**Re: Fern Bay Seaside Village**

As requested we have reviewed the matters raised in Pauline Hon (Department of Planning – DoP) email of 11 December 2009 and updated the information contained in our November 2007 letter report accordingly.

Responses to each of the matters raised in the DoP email of 11 December 2009 are provided below:

FIGURE 1

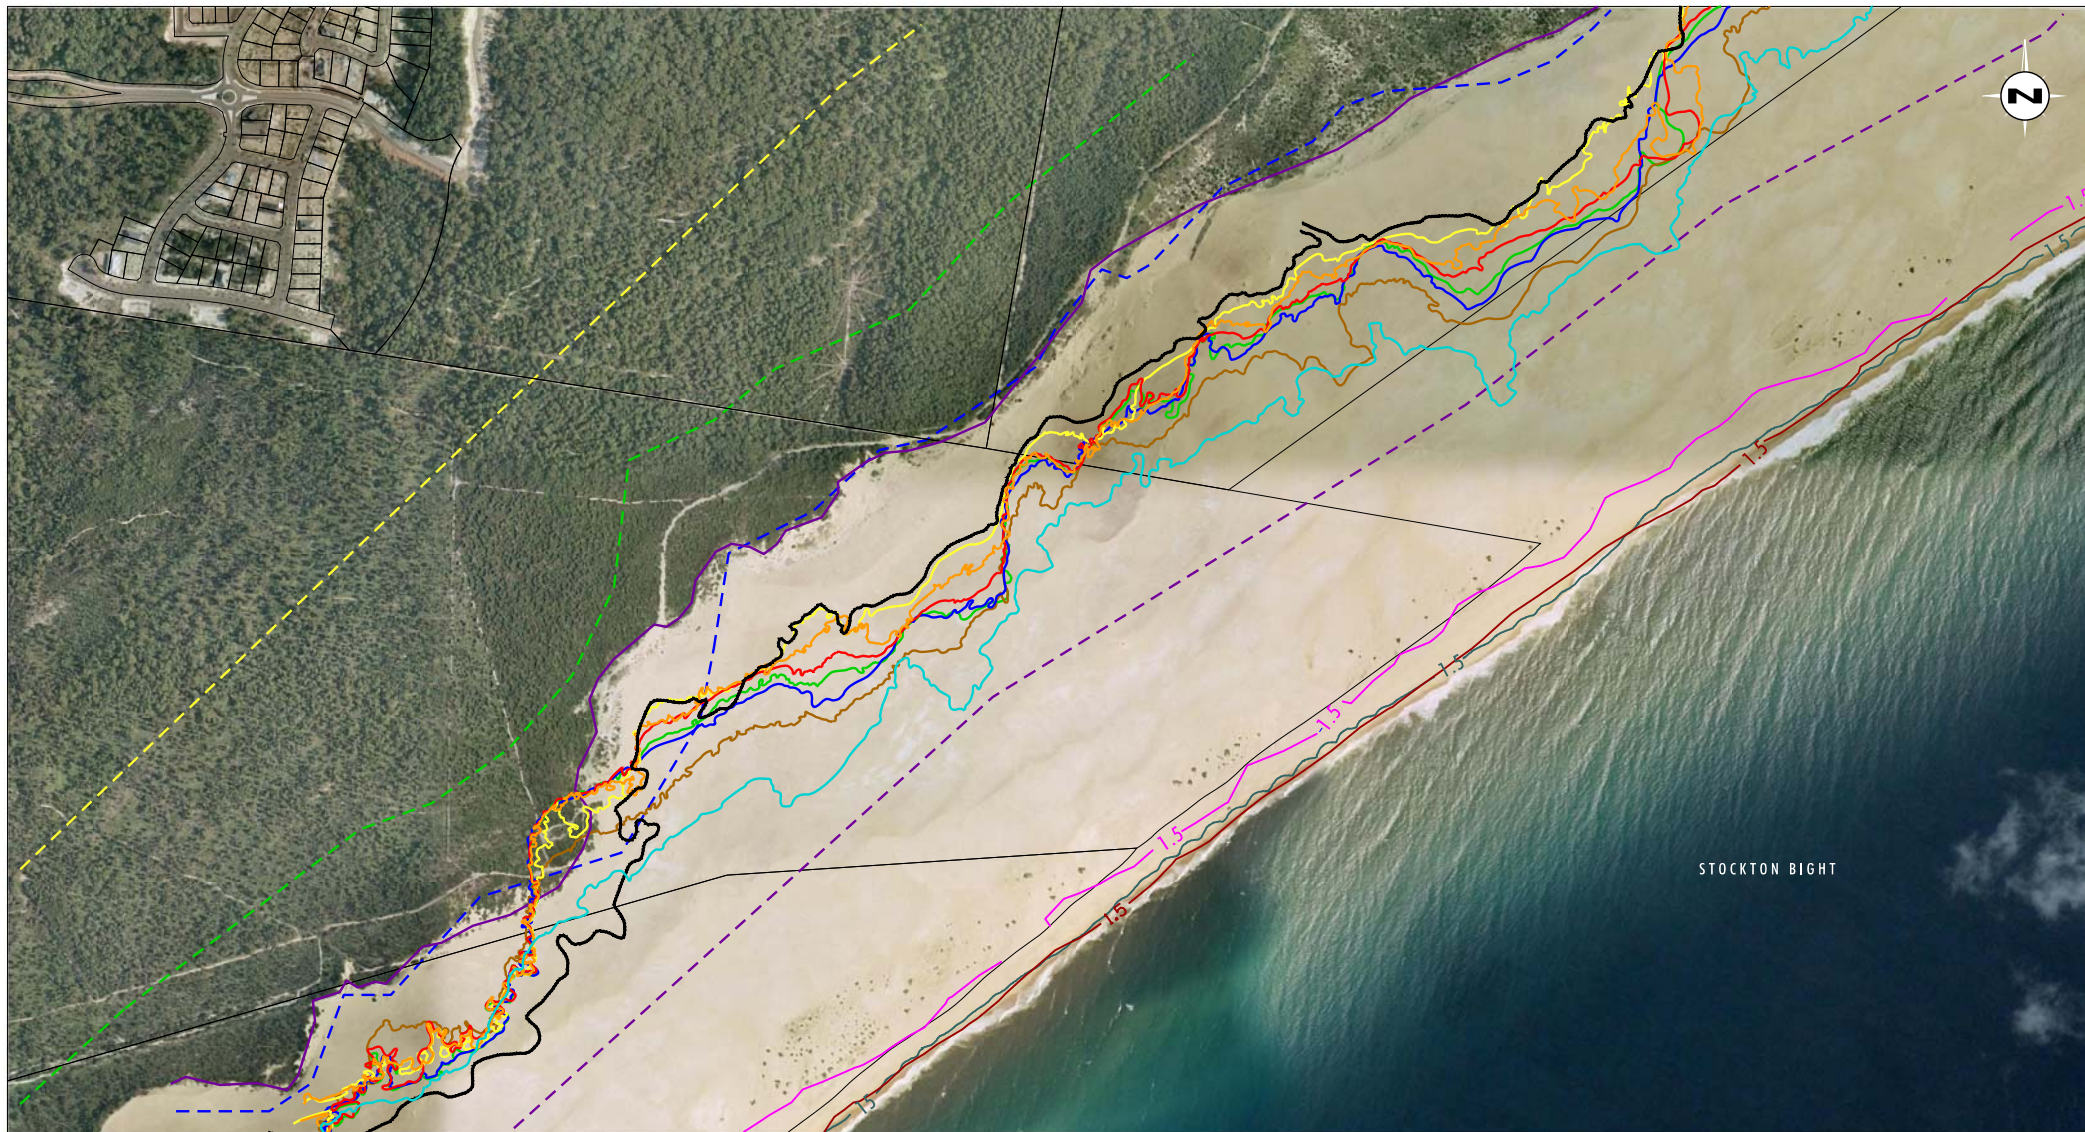
b) Provide an assessment (as a minimum in the form of a comparison of available aerial photography over this time from either DECC or Department of Lands) of whether there has been further progradation or recession over the most recent period to support the argument that recession is substantially reduced from that assumed in AWACS (1992a, b and 1993).

The analysis of available topographic data shown on Figures 1 and 2 shows that the shoreline has aggraded (i.e. moved seaward) between 1954 and 1994 and remained in approximately the same location between 1994 and 2007. Analysis (see Figure 2) shows that the current 2007 shoreline at 1.5 mAHd (approximately high water mark) is shoreward of the 1954 location by approximately 20 to 50 metres indicating the beach has aggraded over the 53 year period at an average rate of approximately 0.4 to 1 metre per year compared to the 1.2 metre per year beach recession rate predicted in the AWACS 1992 report. Analysis indicates that between 1994 and 2007 beach aggradation and beach recession have been negligible. Based on this analysis the 100 year beach recession component set out in Table 1 could be reduced to between 0 metres and -20 to -50 metres rather than the +120 metres used by AWACS (1992).

The analysis provided on Figure 1 shows that the rate of landward dune transgression has reduced with the current landward edge of the unvegetated mobile dune system in approximately the same location as plotted by AWACS in 1992. In addition to this, as shown on Figure 2 heavy mineral sand mining activities that occurred between 1994 and 2007 survey periods moved the mobile dune mass seaward of its 1994 location lowering the height of the major hind dune system by approximately 2 to 3 metres and lowering the height of the small dune system between the hind dune and the Fern Bay Seaside Village site by approximately 5 metres. As a result of the seaward sand movement that was undertaken as part of the heavy mineral sand mining activities, the amount of sand available to be transported onto the Fern Bay Seaside Village site has been substantially reduced.
